PROJECT: Summerlin West Village 30A - Rough Street Grading -  
Update #1

| <b>SUBJECT:</b><br>Drainage Study for:<br><b>Summerlin West Village 30A – Rough Street Grading –<br/>Update #1</b> |                                           | <b>COPIES TO:</b><br>Atkins                                                                       |

#### 2<sup>nd</sup> Submittal: Update to add improvement plans with riprap for erosion protection

Rough Grade Technical Drainage Memo Update

PLAN AND PROFILE - RESERVOIR ACCESS ROAD  
STA 20+00 TO 23+75

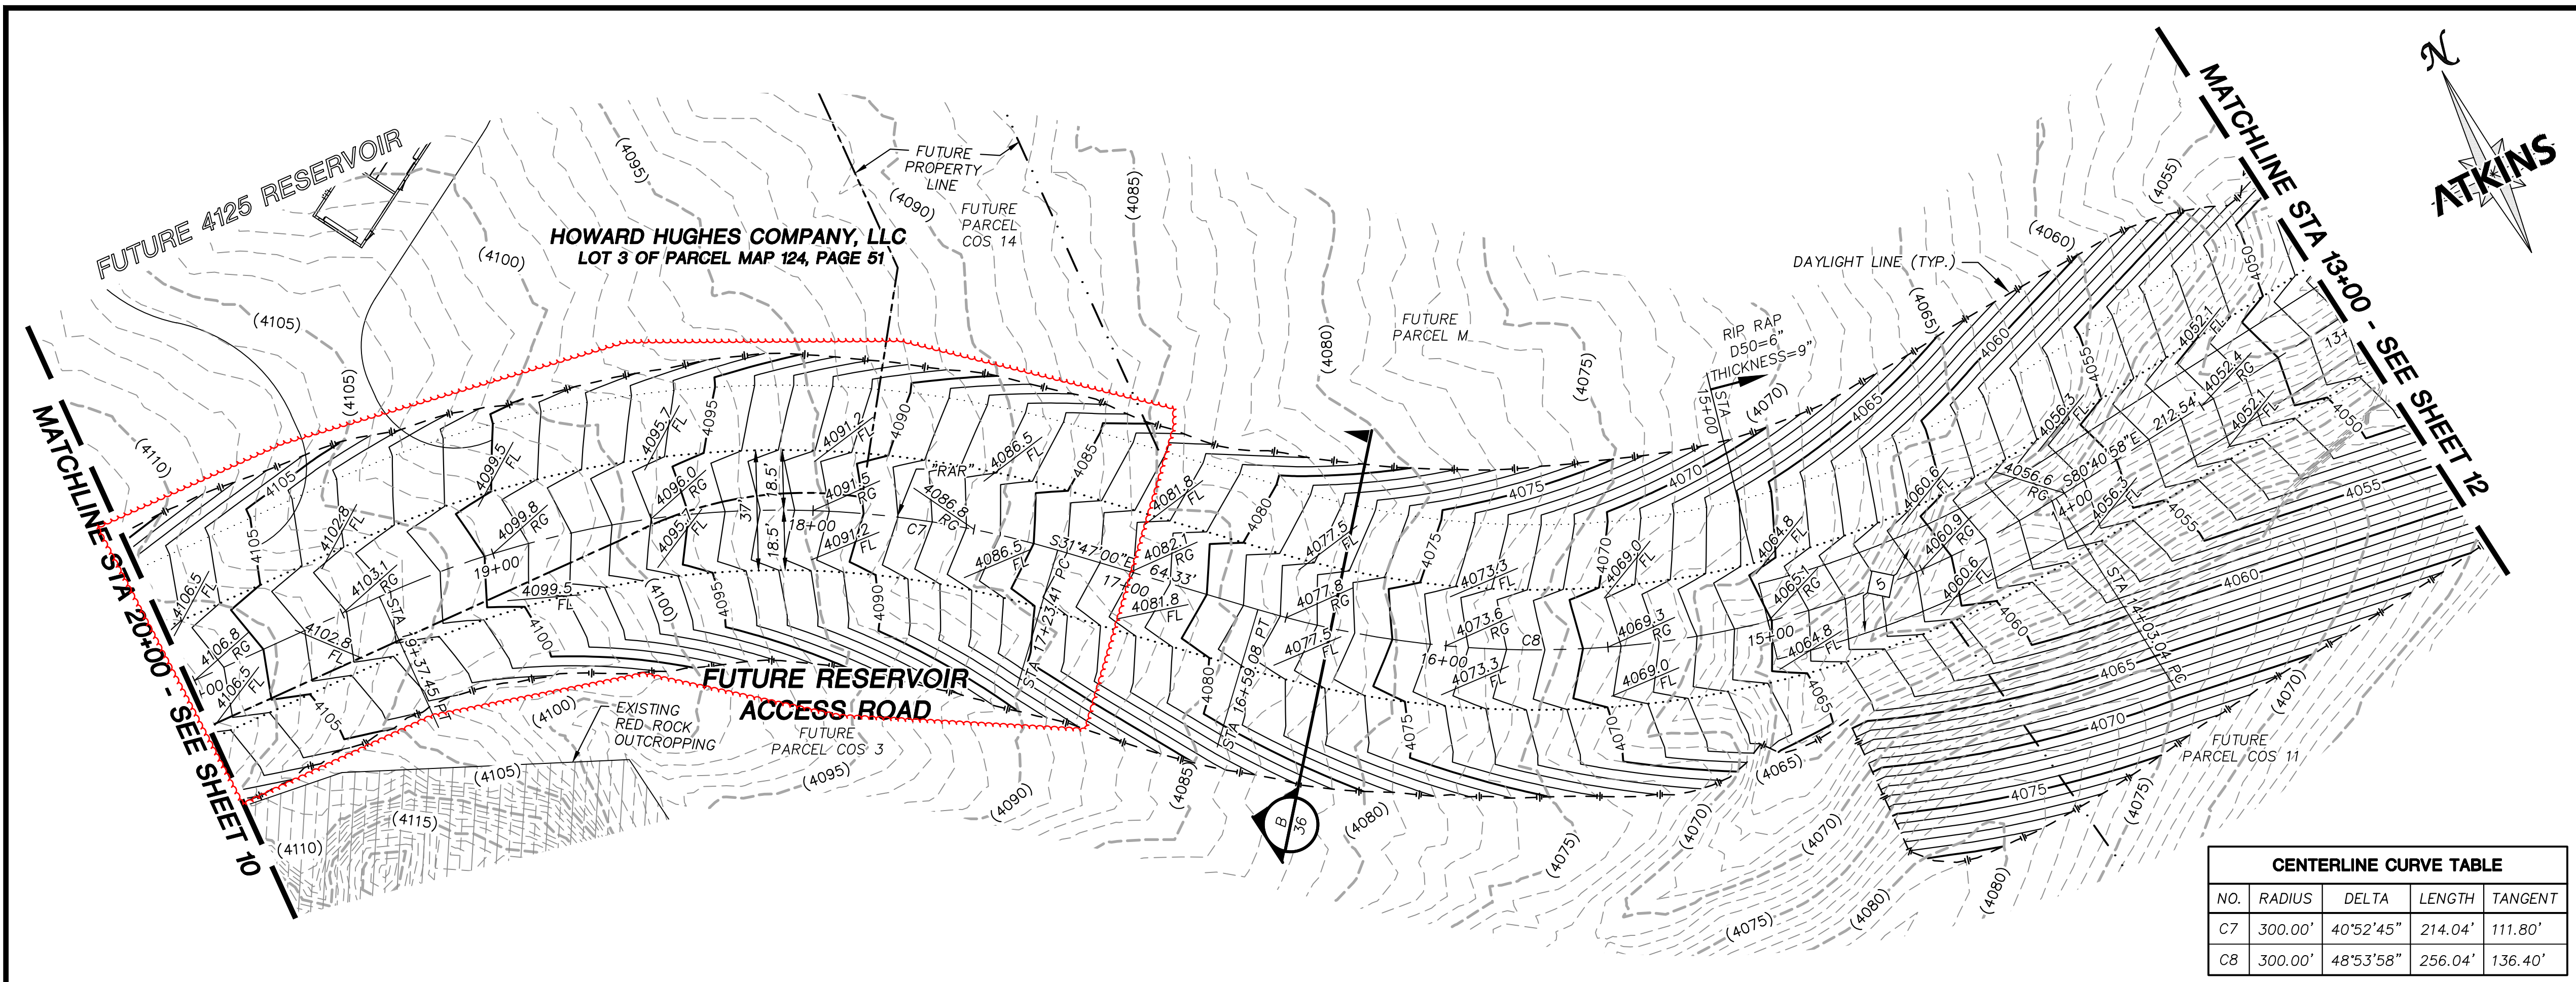
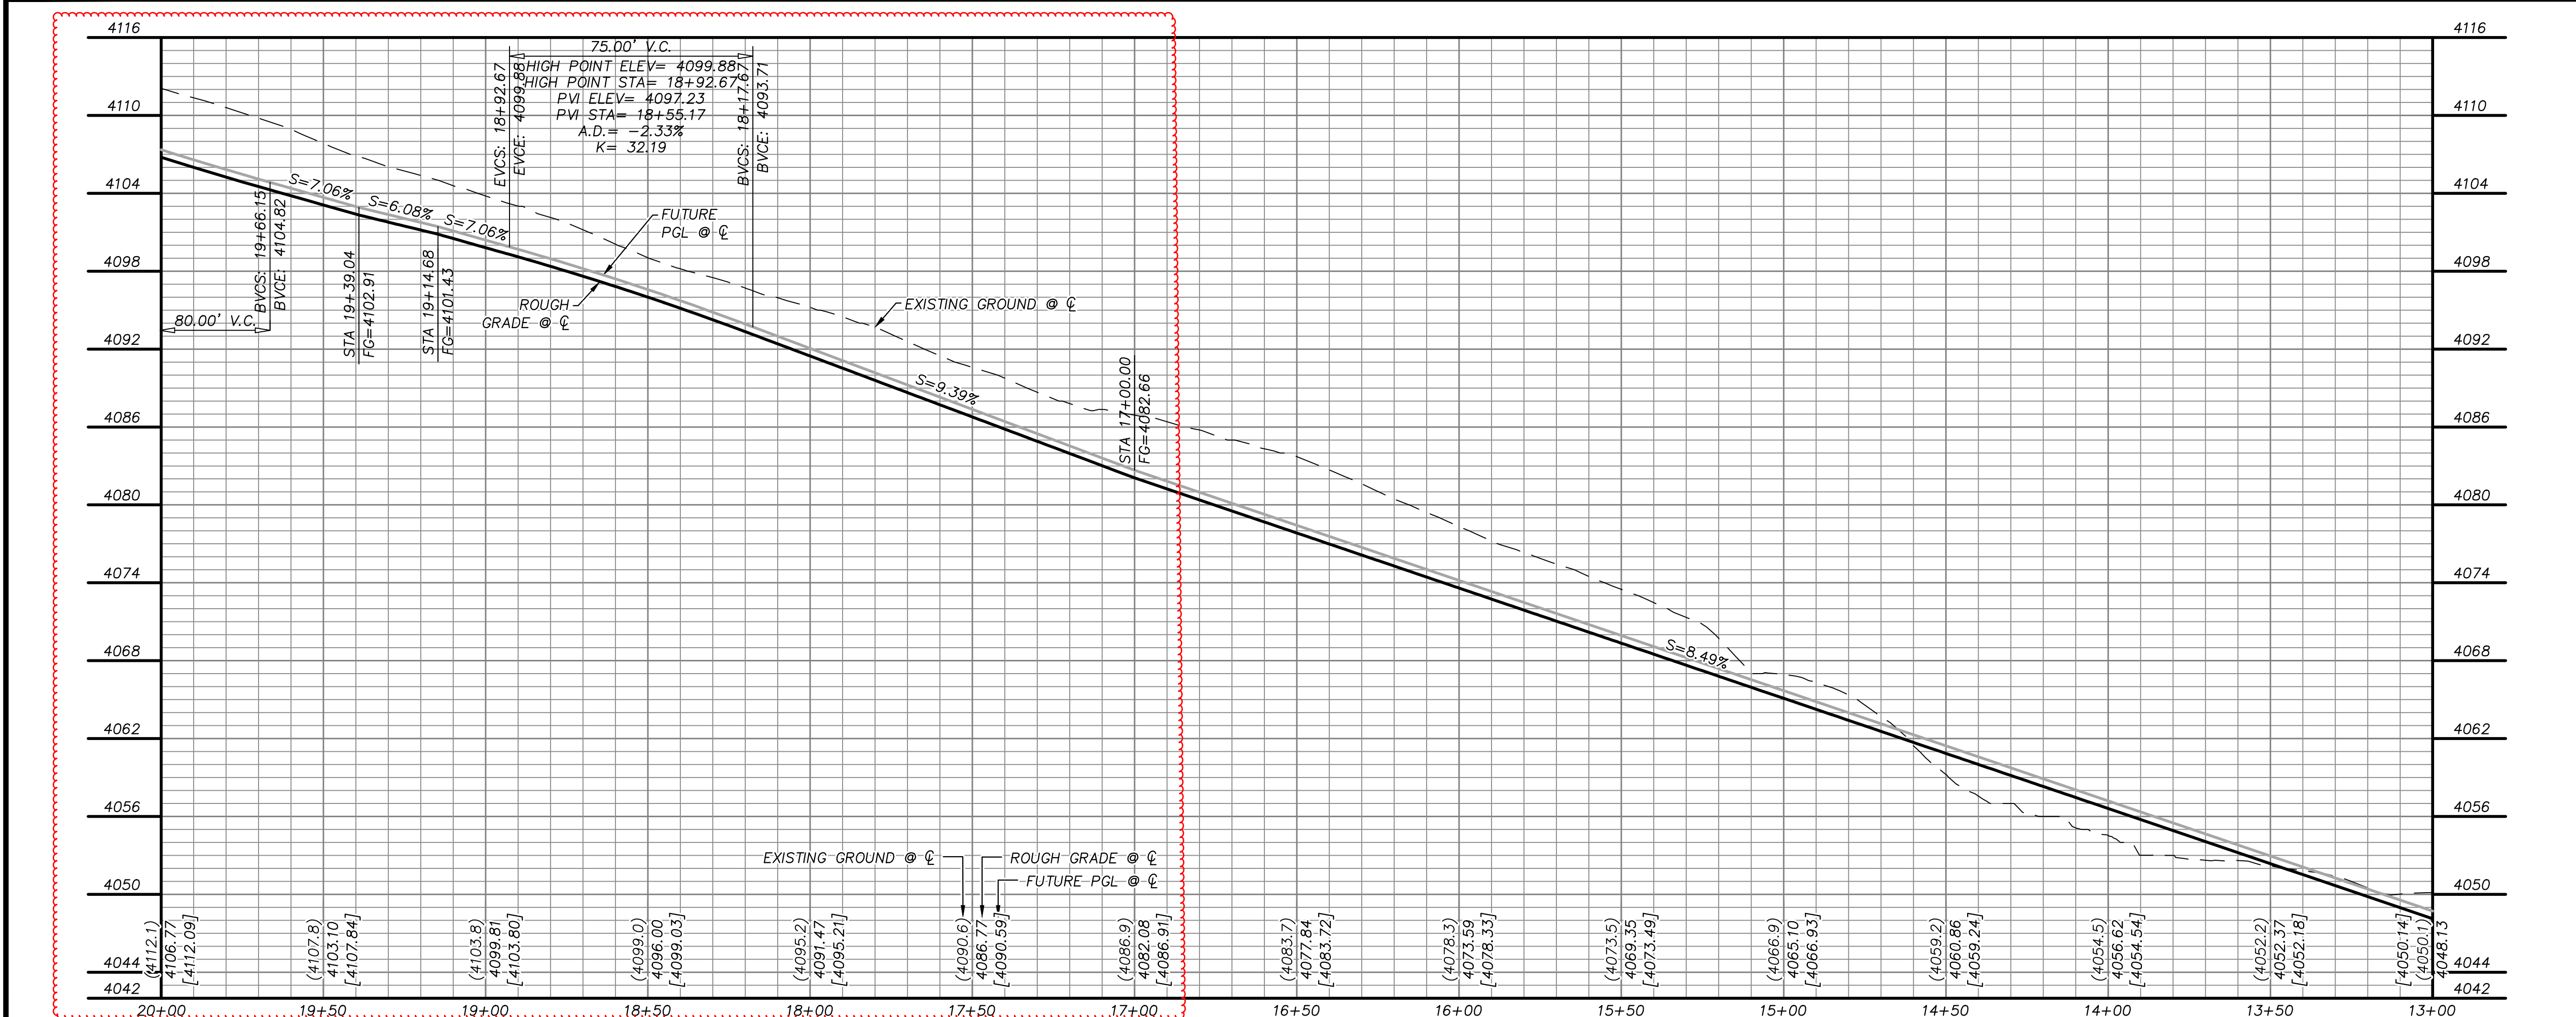
1. In all pertinent improvement plans storm drain construction notes, revise the thickness of riprap to be two times of the D<sub>50</sub> size. Construction Notes #5 to #9 showed only 1.5 times are not adequate. Review and revise accordingly.
2. The approval of this drainage study is for the issuance of rough grading permit for future streets and temporary construction access only.
3. Howard Hughes Company (Summerlin) is solely responsible for the maintenance and erosion control of the interim facilities.
